SERVICE BULLETIN: JSB 033-1

Subject: Piston Circlips

Affected Models: Jabiru 2200 and 3300 Engines

Figure 1 – Type A (Left) & Type B (Right) Circlips¹

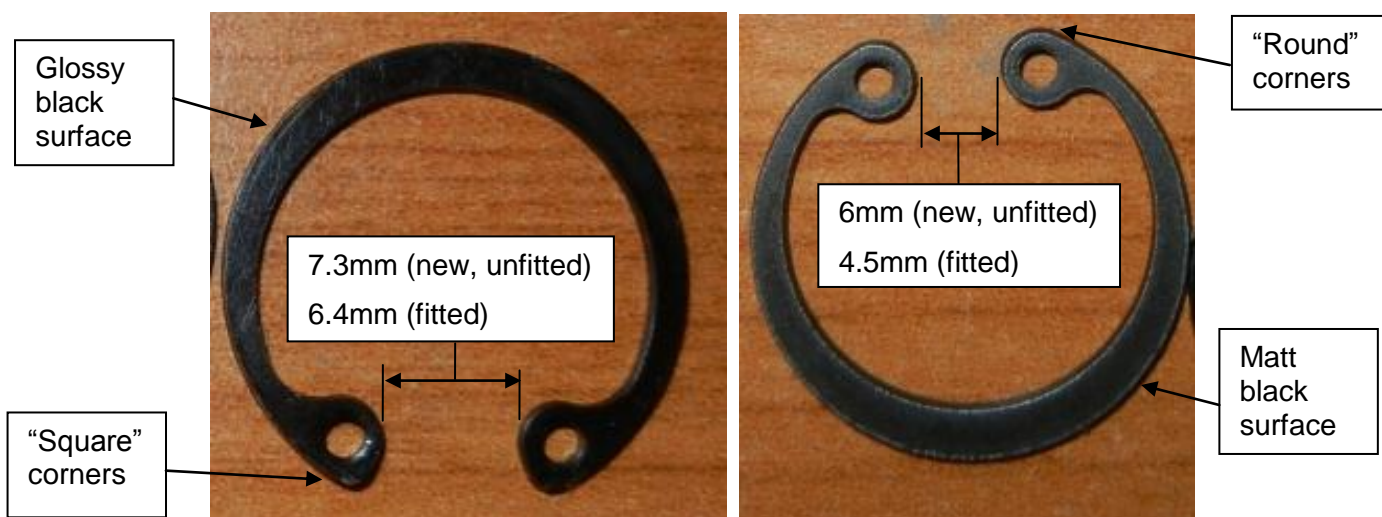
- Subsequent testing has shown that these clips are unusually sensitive to installation technique compared to clips manufactured to DIN 472. In particular, the JIS clips have a larger gap between the clip “eyes” giving greater potential for installers to over-compress and damage the clips on installation. In Figure 1 the “Type A” clip meets JIS B 2804 while the “Type B” clip meets DIN 472.

- In some cases “Type A” clips have dislodged in service leading to heavy engine damage.
- This bulletin details inspection and repair requirements to correct this condition.

- Type B Circlip is Jabiru P/No. PH0545N.

- Disassemble the engine and replace Type A clips with new Type B parts.
- Thoroughly inspect the pistons for damage or wear to the circlip groove. If wear or damage is noted contact Jabiru Aircraft for additional guidance.
- **OR** Return the engine to Jabiru Aircraft or our local authorized representative for correction.

Figure 2 – Clip Installation Details

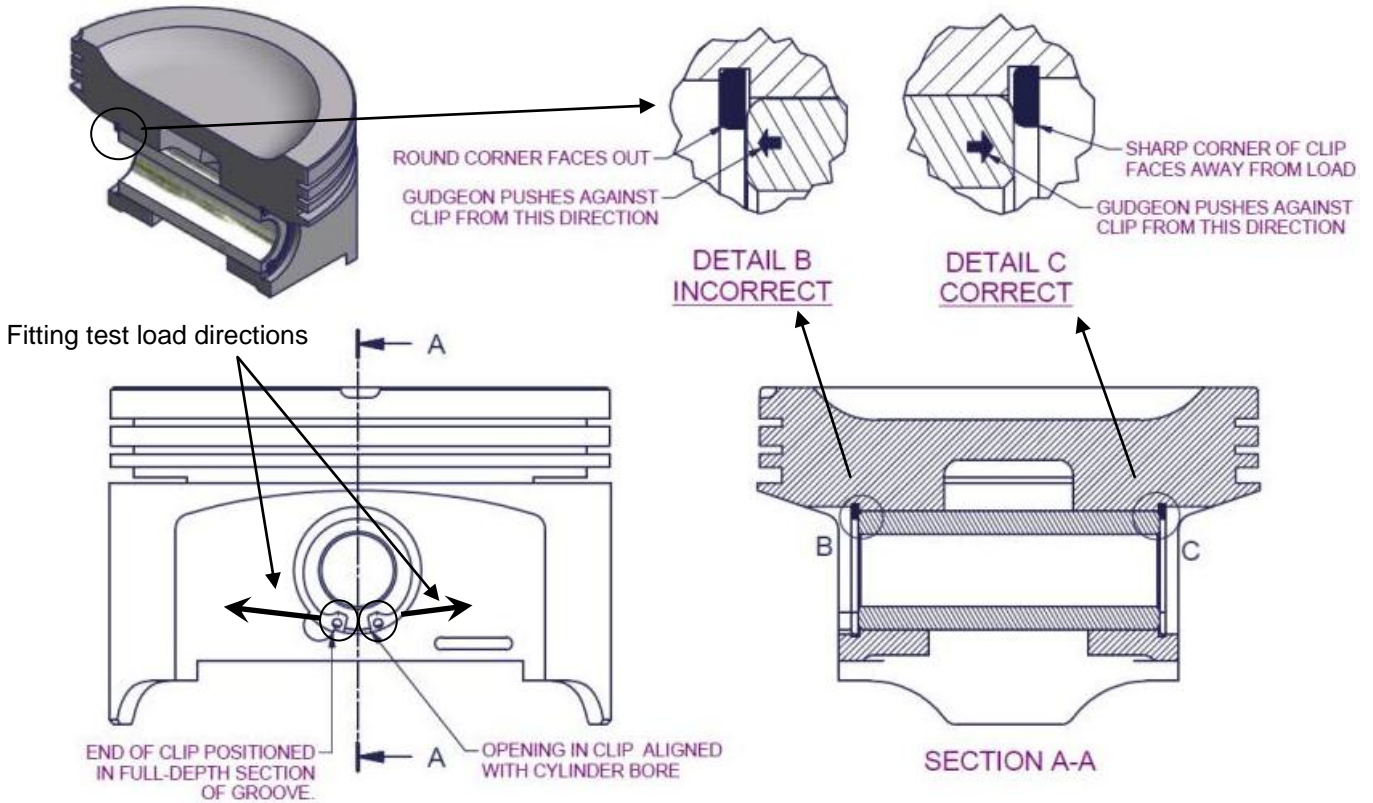
- Clips must be oriented correctly on installation: See Figure 2: the clips must be fitted with the sharp-edged corner facing outwards.
- When installing clips compress them by the minimum amount required for fitting. DO NOT compress them until the eyes of the clip touch.

- Ensure that the opening in the clip is oriented as shown in Figure 2: it must face along the axis of the barrel.
- Ensure that the ends of the clip are both positioned within full-depth sections of the groove as shown in Figure 2.

- After fitting use a small screwdriver or pick to apply pressure to the clip as shown in Figure 2: the clip should not rotate. If the clip moves, discard it and fit a replacement.

Figure 3 – Worn Circlip Grooves.

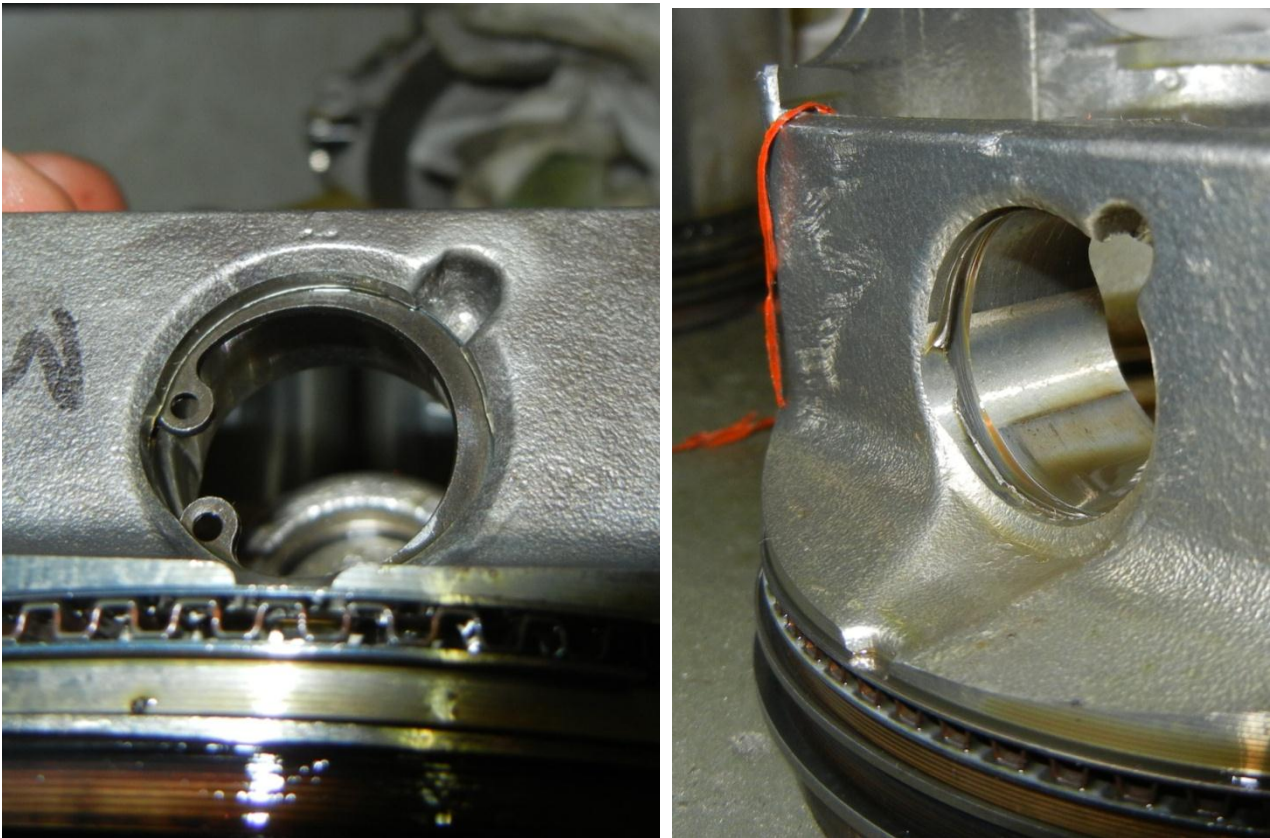
- Thoroughly inspect pistons for wear or damage before installing new clips. Figure 3 shows two pistons with worn grooves. Worn pistons must not be re-used.
